**RICHARDS BAY COMBINED CYCLE POWER PLANT (CCPP), KWAZULU-NATAL PROVINCE**  
**(DEA Ref No.: 14/12/16/3/3/2/1123)**

**COMMENTS AND RESPONSES REPORT**  
**Revised Environmental Impact Assessment Report**

Figure 1: Comparison of annual emissions factors and project case in Page 18 of the Climate Change Assessment

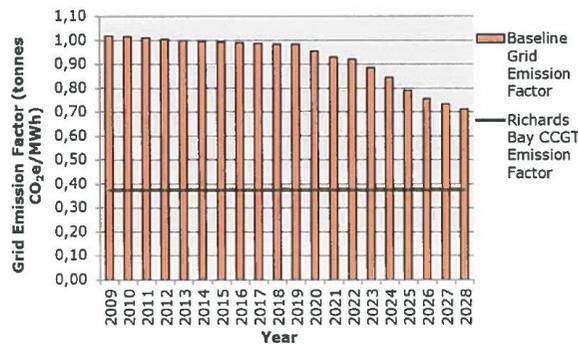
3.5. The position regarding the project not contributing to localized climate impacts on Page 21 contradicts findings in the same report on Page 18 that 0.37 tonnes CO<sub>2</sub> equivalent would be produced. The view offered by the municipality is that CO<sub>2</sub> is a greenhouse gas contributor and therefore linked to climate change regardless of locality. The municipality can moreover vouch that localized climate change impacts have been experienced. (uMhlatuze Vulnerability Assessment 2010, Climate Change Action Plan 2018).

<p>3.6. The comparison between Baseline grid emission and the proposed gas to power plant on page. 18 is useful. Clarity is however sought as to whether the Baseline Grid Emission Factor refers to CO<sub>2</sub> 3/per unit energy from conventional coal fired power stations.</p>		<p>The independent specialist who undertook the Climate Change Assessment (<b>Appendix J</b> of the revised EIA Report) has provided the following response to the comment:</p> <p>The units of measurement relating to baseline grid emission factor and the Richards Bay CCPP emission factor are in tCO<sub>2</sub>e /MWh. This is consistent with the unit of measurement used in the updated version of South Africa's Integrated Resource Plan (published for public comment in August 2018), depicted in figure 4 of the Plan.</p> <p>The draft Integrated Resource Plan is based on different sources of electricity, which vary from conventional coal fired power stations to renewable energy facilities. The total emissions therefore include emissions from all power generation in the country, including coal and renewables, divided by the total electricity consumed (which includes coal and renewables).</p> <p>While the Integrated Resource Plan provides for increased electricity supplies from renewables on an ongoing basis, coal is expected to continue to supply the bulk of the country's electricity needs in the near-medium future (as plotted on the graph in figure 4, which shows the national grid emissions factor levels from 2009-2028).</p>

The independent specialist who undertook the Climate Change Assessment (**Appendix J** of the revised EIA Report) has provided the following response to the comment:

The level of greenhouse gases (typically measured in tCO<sub>2</sub>e) emitted by local activities can be measured (for example, the figure of 0.37 tCO<sub>2</sub>e/MWh provided on page 18 of the report). The impacts of greenhouse gas emissions are however measured on a global scale, as opposed to other pollutants which may contaminate air, water or soil. This is because greenhouse gases that are released into the atmosphere trap some of the earth's outgoing energy, thus retaining heat in the atmosphere. The trapped heat causes changes in the radiative balance of the earth, which alters climate and weather patterns at global and regional scales.

While the municipality can measure climate change impacts within the boundaries of the municipality, such as increased instances of severe weather events, it is not possible to link the impacts with any particular source of greenhouse gas emissions. This is not the case for other, local pollutants. For example, it may be possible to link water pollutants to certain industrial activities based on the nature of the pollutant measured in the water
